# THE STANDARD AT SEATTLE - THE TOWERS

## RECOMMENDATION MEETING

DPD PROJECT #: 3033094

RECOMMENDATION MEETING: MARCH 23, 2020

### 1A. 1C. PARTI - A SIMPLIFIED DIAGRAM

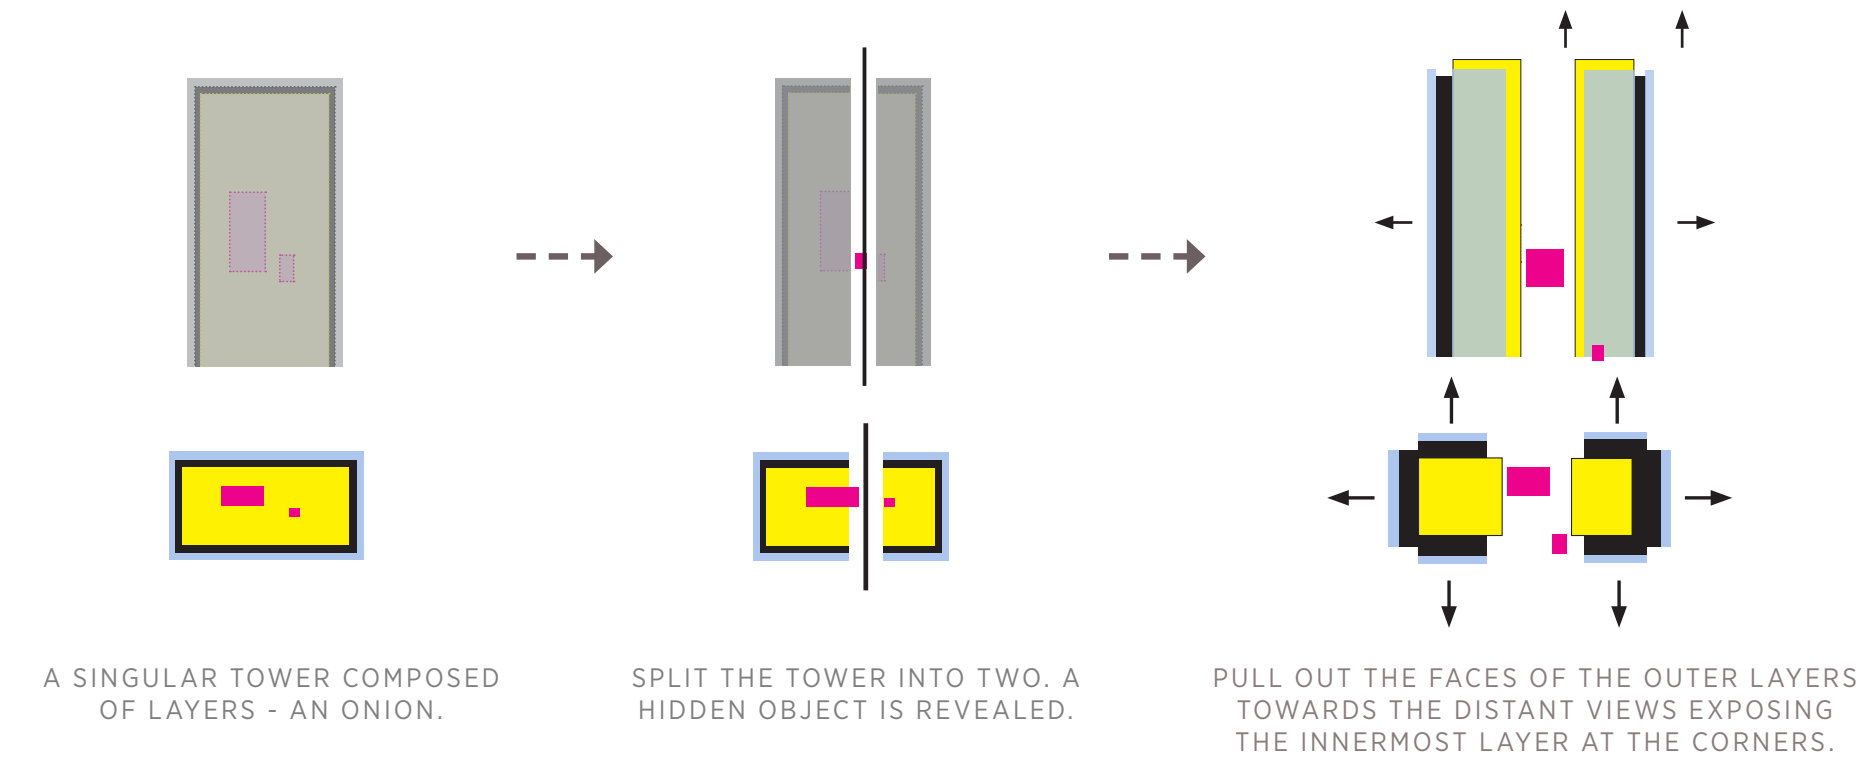
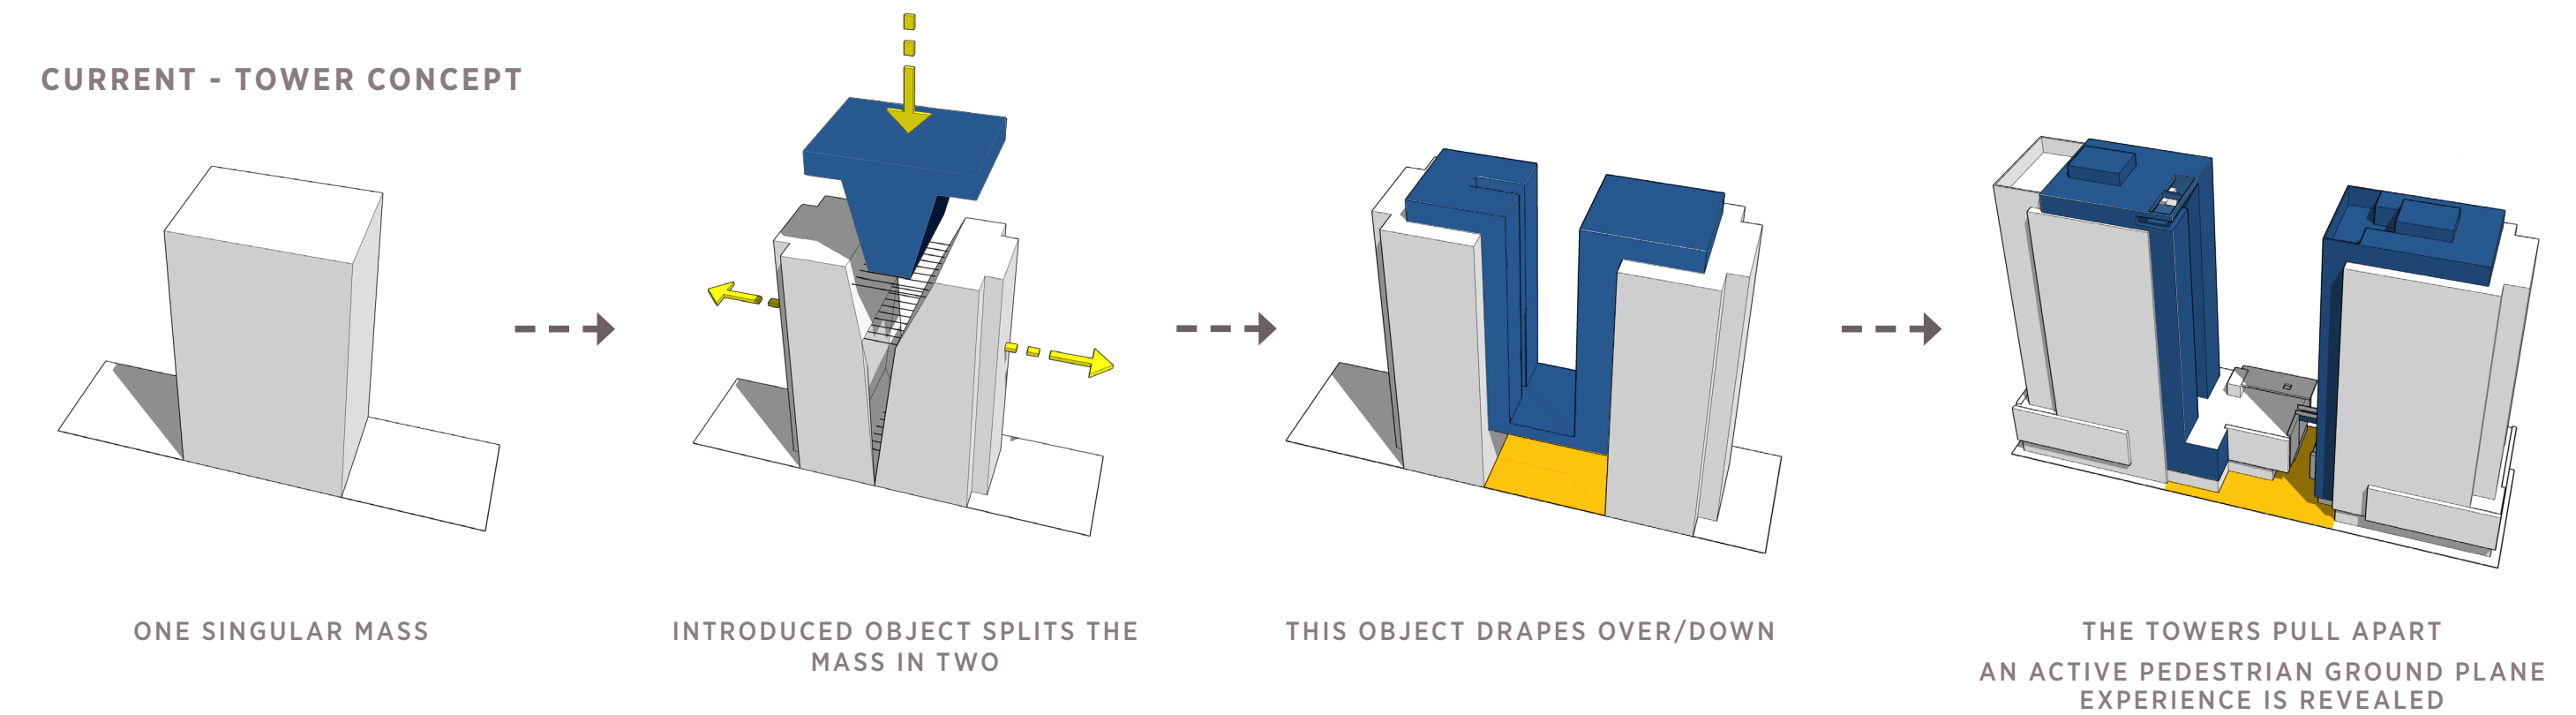
ITEM	EDG SUMMARY	RESPONSE
<b>1 OVERALL DESIGN CONCEPT</b>		
1A. PARTI	The Board supported the idea of a singular form cleaved apart by elemental forces, with a shell largely intact but split in two, dynamically exposing the “muscle” material within. (CS2-A, DC2)	The project diagram and concept have been refined and simplified to support this idea.
1B. UNIQUE TEXTURE	The Board expressed strong support for the unique faceted texture of the exposed inner element and suggested exploring the possibility that this material reoccur at other points in the project. (DC2, DC4)	This material was brought onto the underside of the connecting bridge element as the last tenuous connection between a once singular object.
1C. SIMPLE DIAGRAM	The Board was less supportive of the complexity added to the project by additional forms and layers of material and suggested that a return to the simplicity of the diagram would strengthen the design concept. (DC2)	The project has been simplified to limit the forms and layering of materials on the building.

#### CURRENT - TOWER CONCEPT

THE JEWEL POSSIBILITIES - OPEN SPACE BETWEEN BUILDINGS, RESPONSE TO LANDSCAPE, OR ACTIVITY GENERATING SPACE?

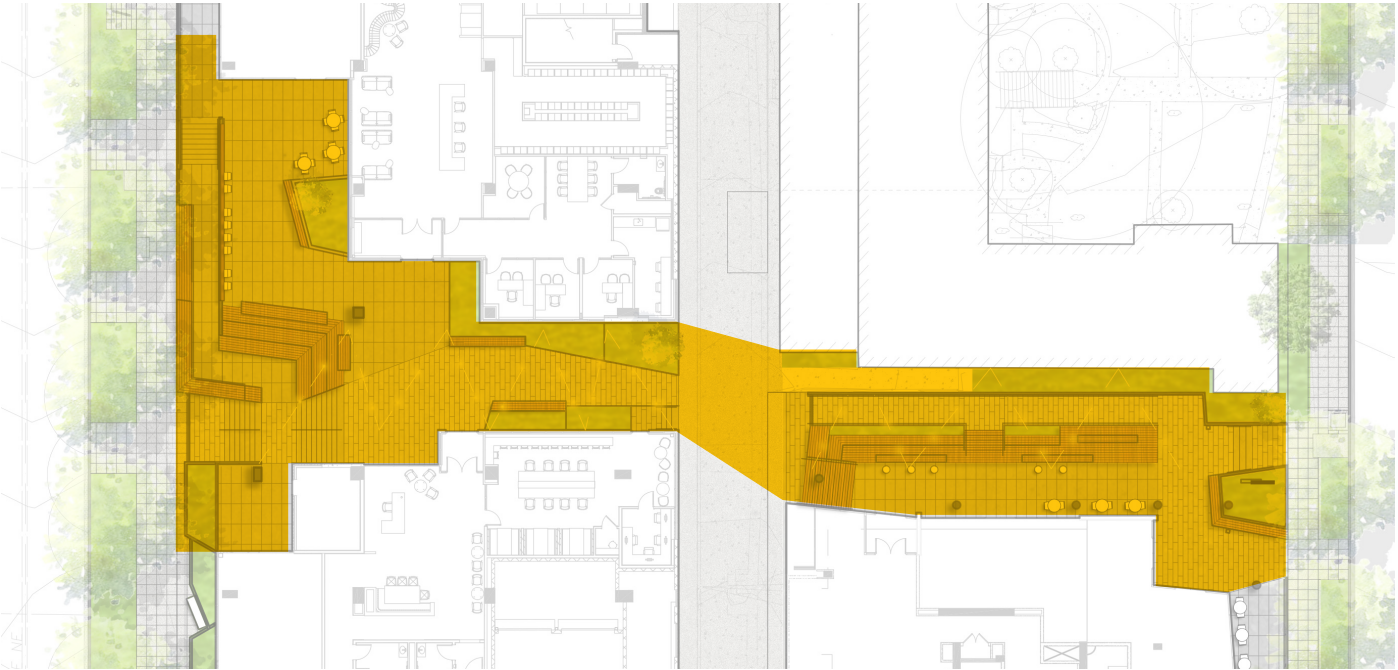
<b>2 JEWEL DESIGN CONCEPT</b>		
2A/B. CONCEPT AND EXTERIOR EXPRESSION	The Board discussed the character of the jewel element and its importance in the design concept. the “standard programming” behind its very different exterior expression compromised its support of the design concept. (DC2)	EDG Discussion
2C. POSSIBILITIES	1. Think of the open space between the buildings as the jewel. 2. The physical manifestation of the jewel in the first 40’ could be a response to the landadscape plan. 3. The jewel concept could be expressed as an activity generating space.	The revealed jewel is no longer envisioned as an object but, rather, a dynamic open space, activated along its edges with public and private interactions. Entries from both retail and residential lobbies focus inward into this space to give it physical connections, while glazing fronts all sides of the jewel giving it continuous visual connections as well. Balconies have been introduced at the podium levels above the mid-block connection to provide visual and physical activity up high within the space. A colored, meandering element weaves its way through the space linking sidewalk to sidewalk.

The EDG-02 Jewel was an object that had no other purpose other than it strived to be different. It had no connection to the overall design. And, it was inherently flawed in that this revealed object was not what was special within the project.

The true Jewel of this project is the active, public mid-block corridor. This is the space that will most impact the pedestrian experience and the neighborhood. The Jewel is a hidden public space that has been revealed.

MINIMIZE GROUND CHANGE THROUGH THE MIDBLOCK CONNECTION

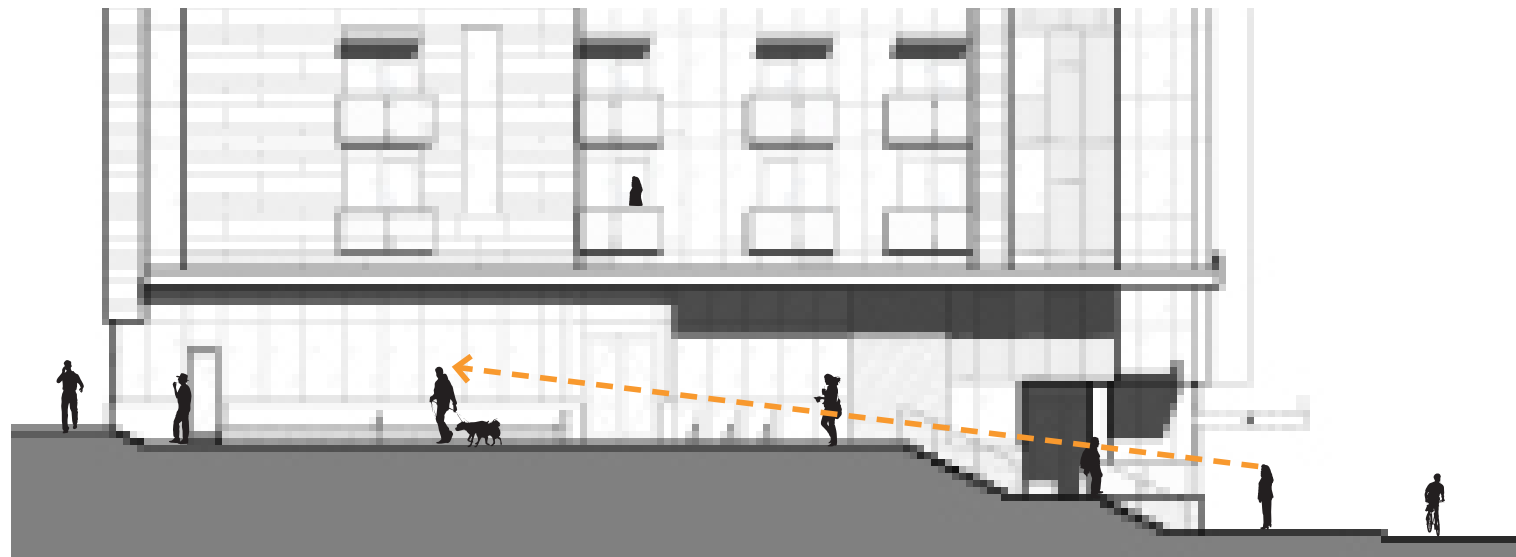
ITEM	EDG SUMMARY	RESPONSE
<b>3 MID-BLOCK CONNECTION</b>		
3A. GRADE CHANGE	The Board expressed concern about the amount of grade change through the mid-block connection and encouraged the team to minimize its disruptive effect on the pedestrian experience. (DC3, DC1, PL2, PL3)	The mid-block spaces are larger and have less grade change within them. The raking of the entry steps and rotation of the access stairs have minimized the effect on the pedestrian experience.
3B. 12TH AVE. ACTIVITY AREAS	The Board encouraged the team to create activity areas at the levels close to 12th Avenue to draw passers-by into this open space. (PL3)	The access stairs have been rotated north/south and the planting in the plaza has been moved up against the building to create more active space along 12th Ave. The southern retail perch has been enlarged and lowered closer to sidewalk grade. The larger stadium seating creates additional active edges.

By rotating the north entry stair, and removing the stepping at the south retail outdoor area, the project is able to capitalize on larger single grade areas facing the 12th Avenue sidewalk. The walkway leading to the alley intersection slopes to eliminate the need for steps at the alley. The main stairs have been elongated to allow for better sitelines into the mid-block corridor.

BRING THE **RETAIL AREAS CLOSER TO GRADE** AND WRAP THEM AROUND THE CORNERS.

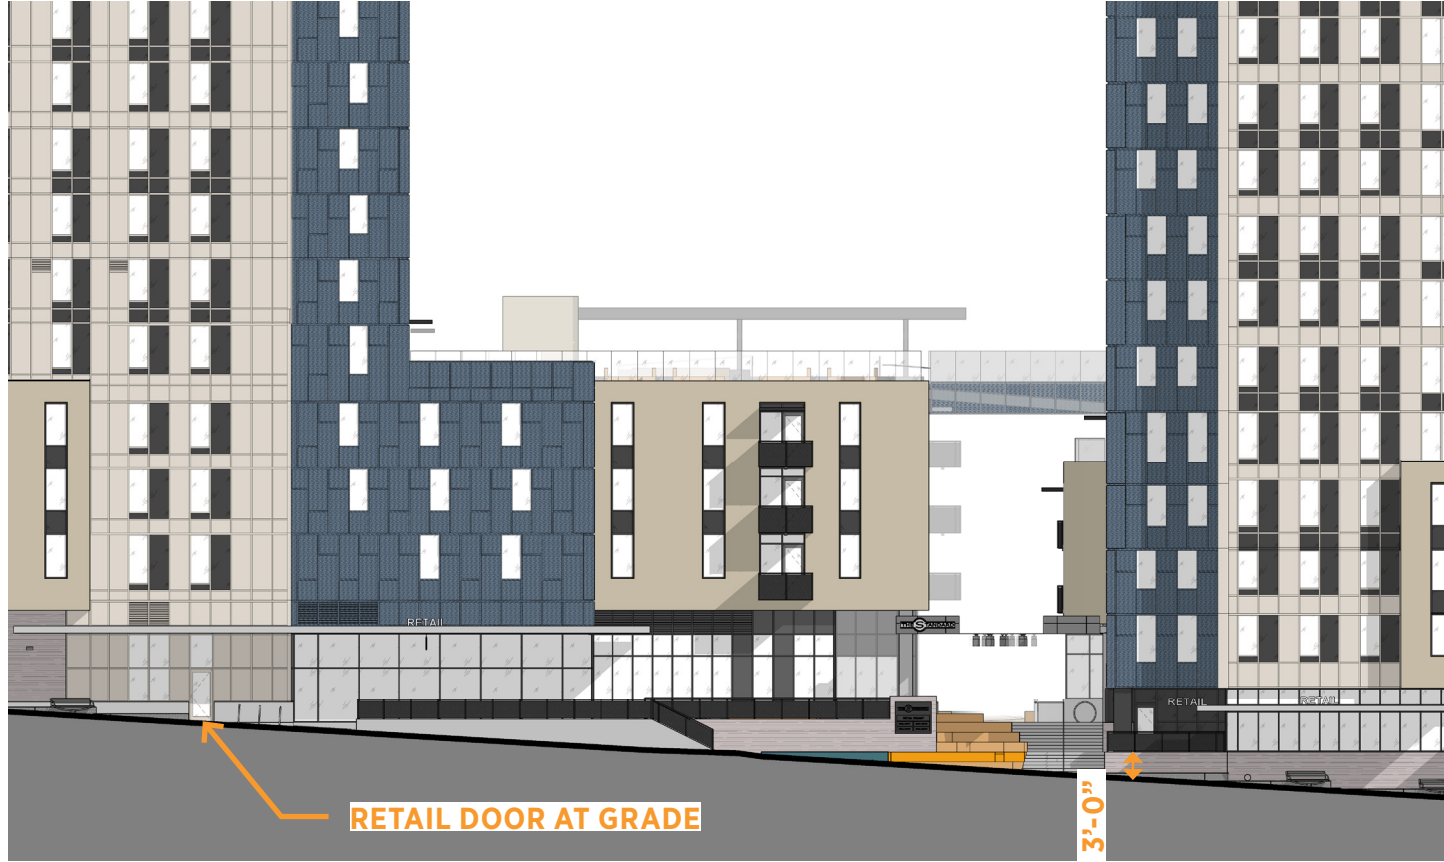
3C. RETAIL WRAPPING CORNERS	The Board agreed the ground floor lobby relationship was strong. They gave guidance the a similar dynamic be created by bringing the retail areas closer to grade and wrapping them around the corners. (DC3, PL3)	The retail wraps around the entry corners into the mid-block corridor. The retail along the southern edge has been lowered to visually connect with the sidewalk.
3D. ALLEY MIDBLOCK ENTRANCE	The Board expressed concern about the eastern (alley) entrance to the mid-block connection and gave direction that it be revised to appear more open and inviting. (PL1-A, CS2-B, PL4-B)	The mid-block opening at the alley has been widened 2’-6” at the ground floor. Glazing wraps the corners on either side of the mid-block corridor at the alley entry creating a strong visual connection between the interior spaces and the alley/mid-block corridor intersection.
<b>4 BASE AND GROUND PLANE</b>

The retail on the south side of the mid-block corridor has been lowered 9". This retail wraps the corner and has its own "porch" overlooking the sidewalk.

The retail on the north side of the mid-block corridor is at the same level as the plaza space. A door has been introduced at sidewalk level on the north end of this retail space to make it accessible from the sidewalk. This retail also wraps the corner into the mid-block corridor.

CREATE SIGHTLINES INTO THE MIDBLOCK CONNECTION

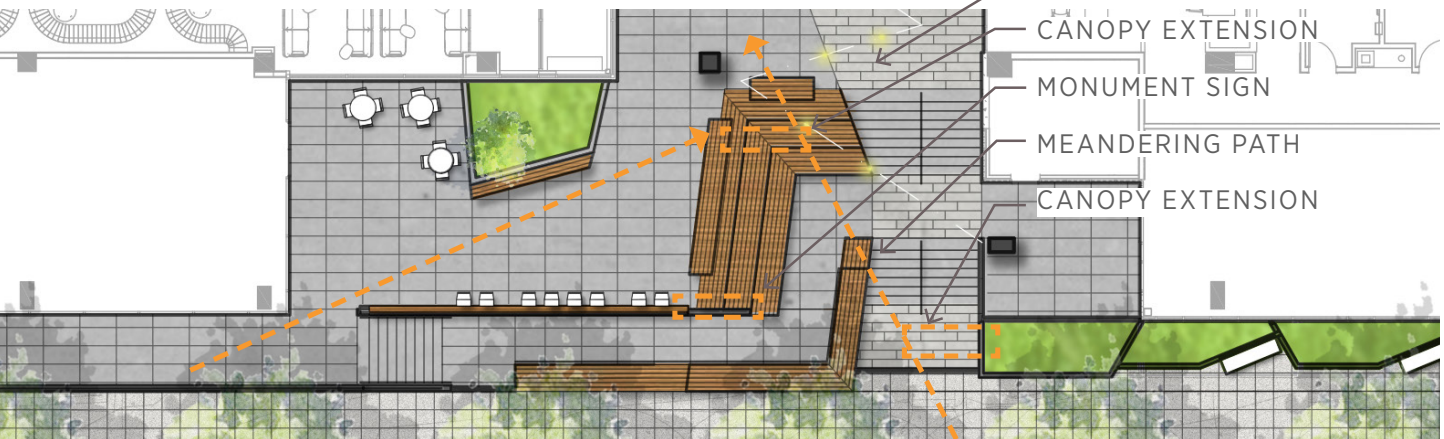
4A. SOUTHWEST CORNER	The Board did not support the configuration of elements at the southwest corner, agreeing that retail uses need to be close to grade to create the human interaction and activity called for in the Guidelines. (PL3-C, PL1-C)	The retail at the southwest corner has been lowered. The level areas outside the retail along the south façade have been split into two levels to mitigate their height next to the sidewalk. The level area outside the western retail has been pushed north away from the corner to minimize the amount of height and stair necessary to access it.
4B. MID-BLOCK CONNECTION SIGHTLINES	The Board agreed the mid-block connection could be a benefit to the neighborhood but were concerned it was not apparent enough from farther up and down 12th Ave. NE. Explore ways to create sightlines to the mid-block connection. (CS3-A)	The lowering of the retail along the southern edge of the midblock entry from 12 <sup>th</sup> has opened up the sitelines into the mid-block connection. The introduction of the larger stadium seating opens up the sitelines from the sidewalk. The walls at all landscaping elements facing the 12 <sup>th</sup> Avenue sidewalk have been lowered to lessen any visual barriers into the space. The overhead canopies have been raised to open up the visual connection. The retail plaza planting has been pushed up against the building to open up sitelines.

The planter on the mid-block plaza has been pushed up against the building to allow for more usable area for seating, and to open up the view through the space into the mid-block corridor. The raking of the stadium seating opens up the view and allows for a gradual transition up into the mid-block corridor.

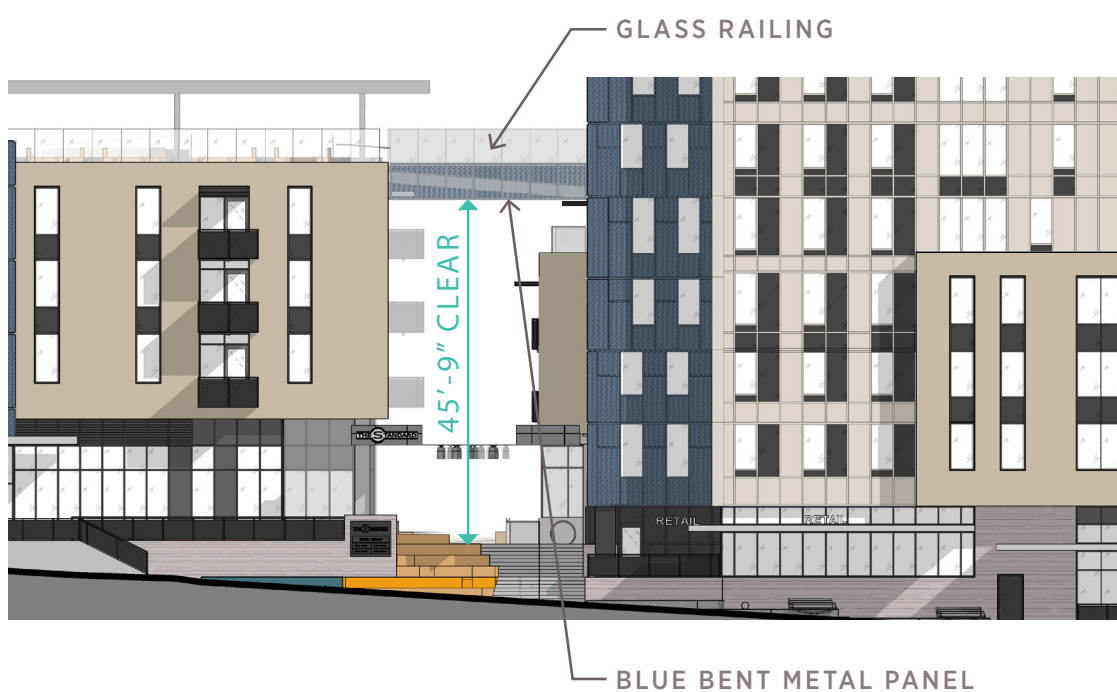
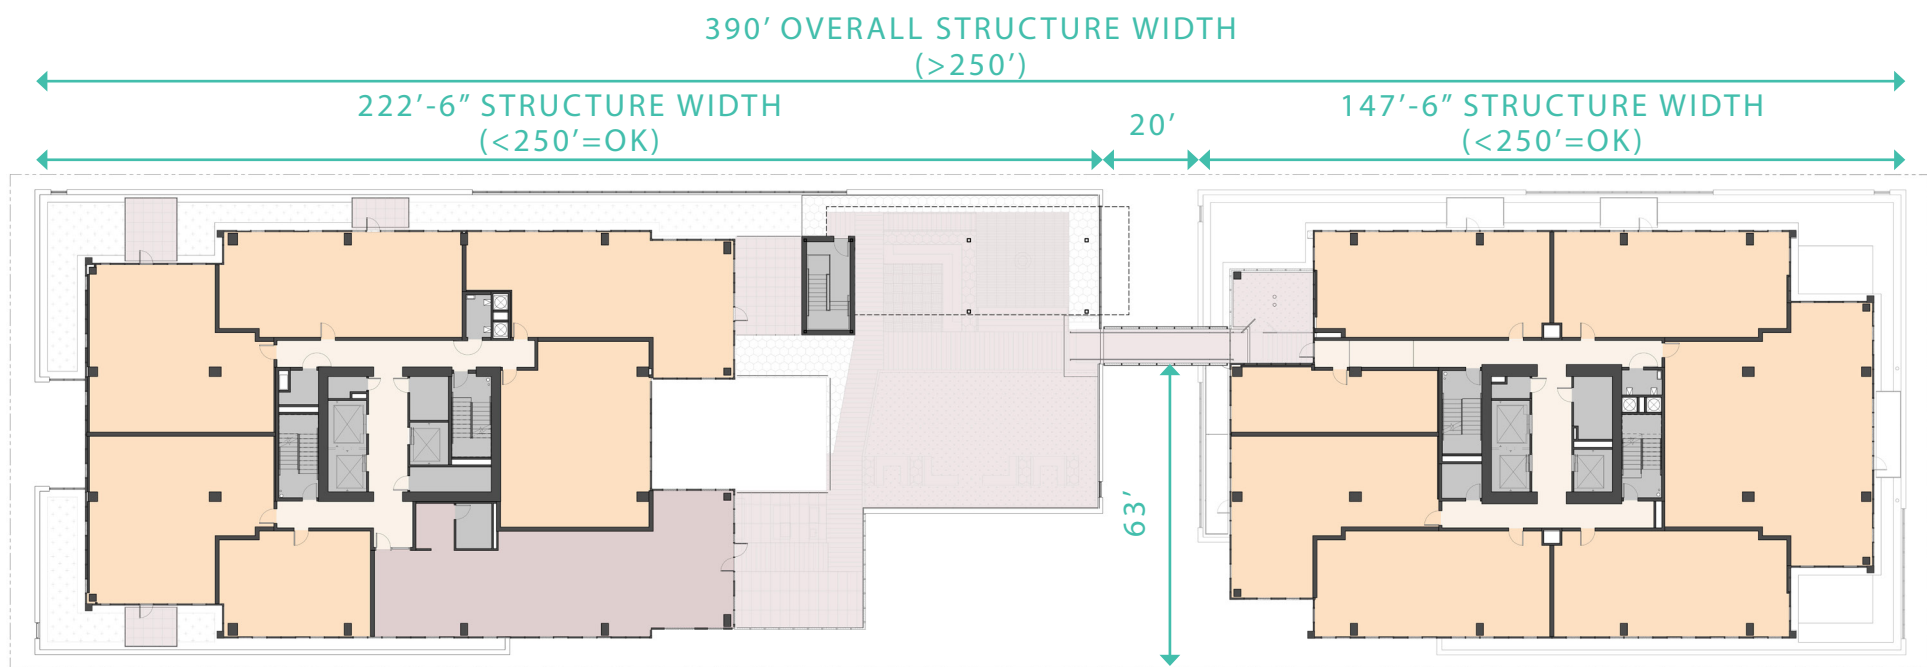
The Board indicated possible support for this departure provided it is expressed as something more than a circulation element and that it supports the larger design concept. (DC2, DC2-6)

The project looks to develop a visual connection between the two towers. The bridge becomes part of the physical stitching between the two structures showcasing that connection, while
